TYRONE TOWNSHIP PLANNING COMMISSION
REGULAR MEETING AGENDA
June 8, 2021 7:00 p.m.

Lake Urban Crossing Preliminary PUD Plan

Planned Unit Development Concept Review for Tyrone Township, Michigan

Planned Unit Development Concept Review (2nd) for Tyrone Township, Michigan

Map 1 – Current Zoning Map

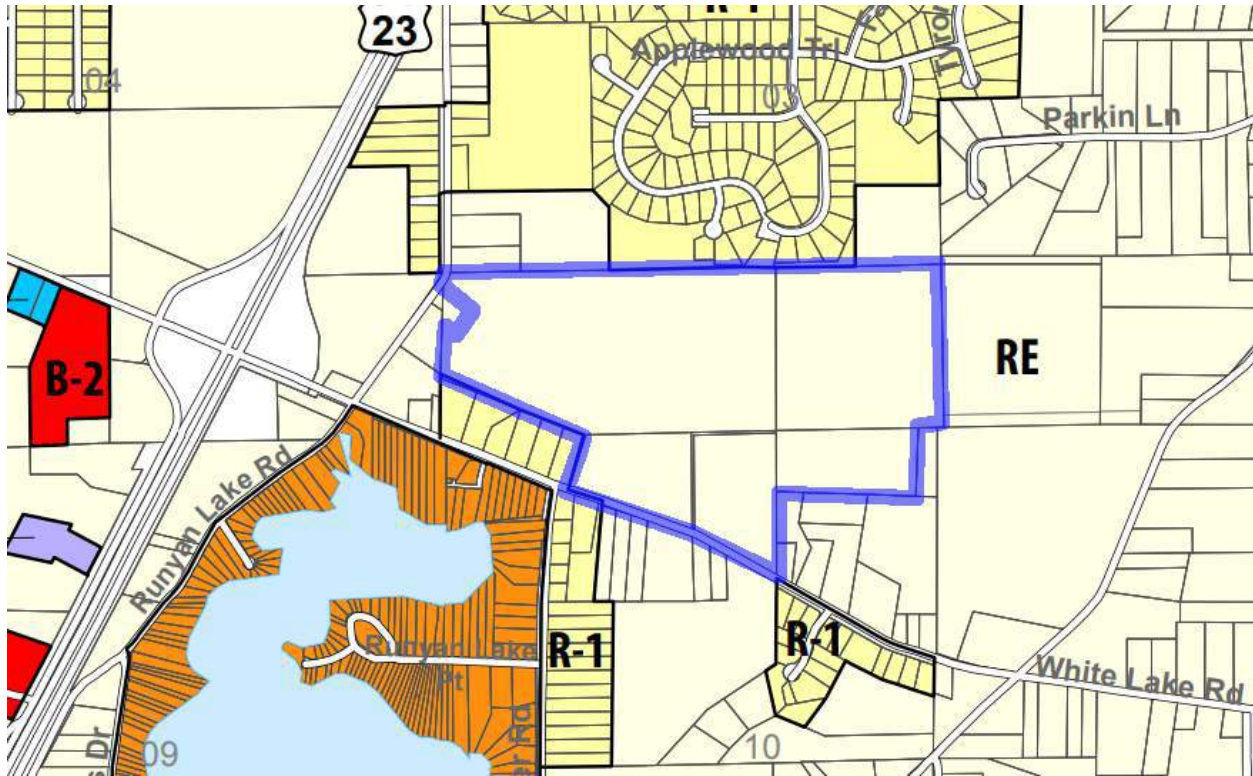
Comments: Based on the Future Land Use Map (later in this report) and the intents above, it may be appropriate for the western portion of the property to receive a zoning map amendment to the R-2 Single Family Residential district.

PRELIMINARY SITE OPEN SPACE PLAN LAKE URBAN ESTATES

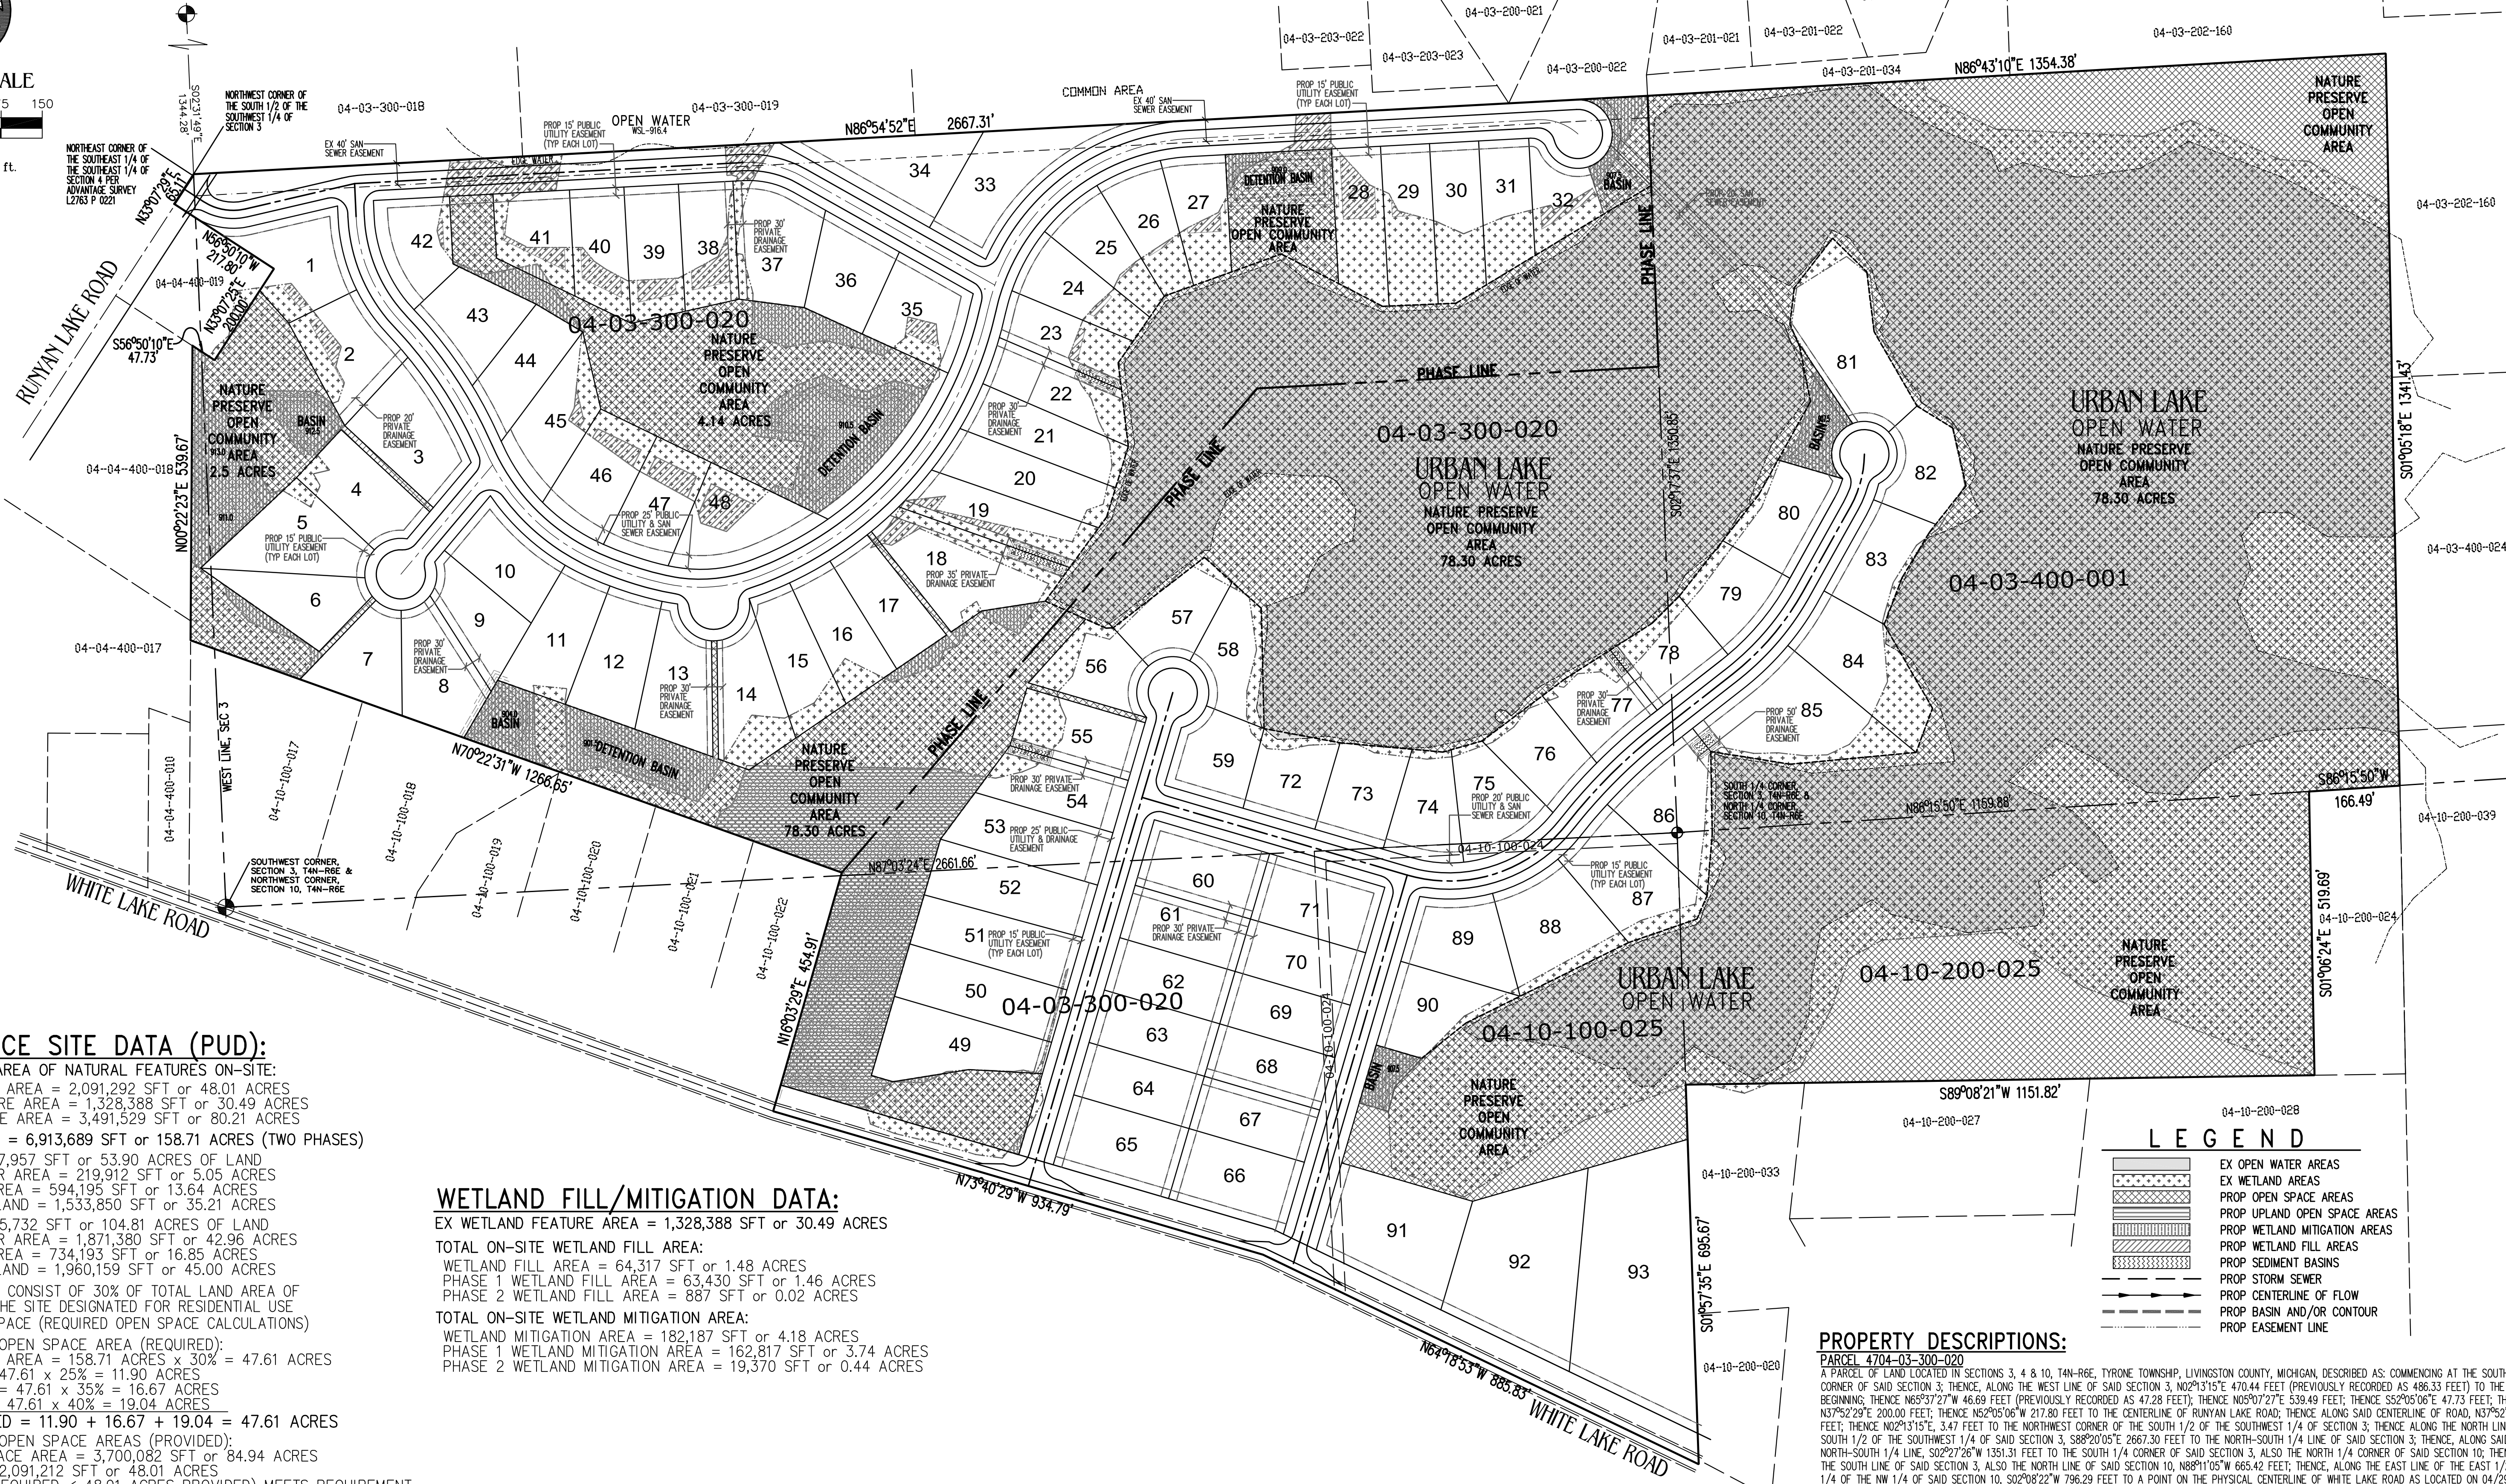
The site plan does not include any landscaping. Space should be provided for landscaping along the northern lot line and along White Lake Road.

Map 1 – Current Zoning Map

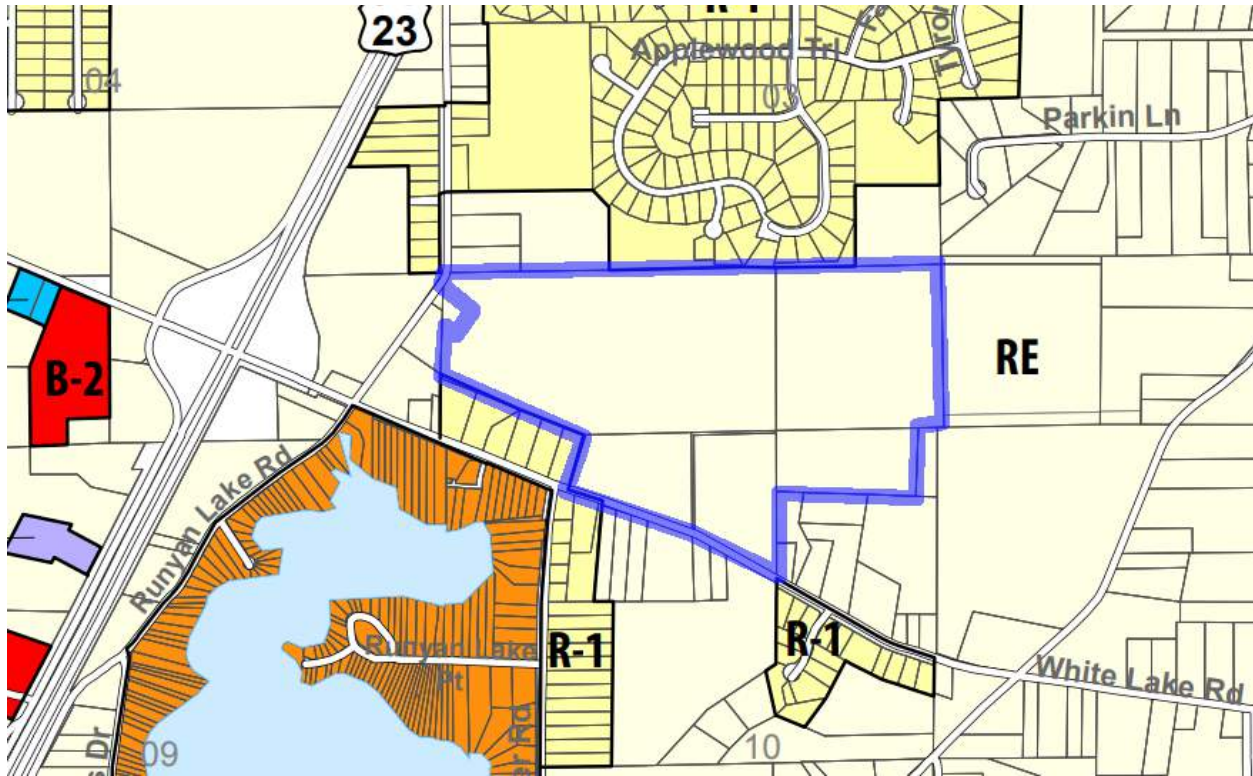
Comments: If the project is approved as a planned unit development, the zoning district in which it is located becomes less important for developmental standards (lot area, setbacks, etc) because modified developmental standards can be approved for the project. Those modified developmental standards would then act as the standards for review/approval of future improvements within the project.
